Working Party on Noise

Report of the Working Party on Noise on its fifty-sixth session

Draft amendments to Regulation No. 51

Adopted text based on GRB-56-03 (see para. 8 of this report)

"Figure 2

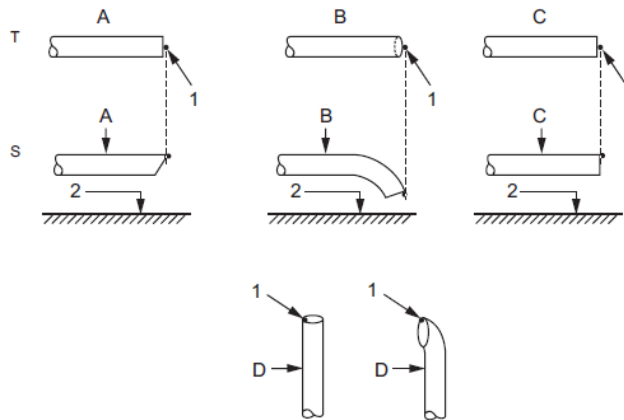
8. GRB considered and adopted GRB-56-03 as reproduced in Annex II to this report, amending the figure for measuring positions of vehicles in motion. The secretariat was requested to submit the proposal to WP.29 and AC.1 for consideration at their March 2013 session as Supplement 9 to the 02 series of amendments to UN Regulation No. 51.

Annex 3, Appendix, Figure 2, amend to read:
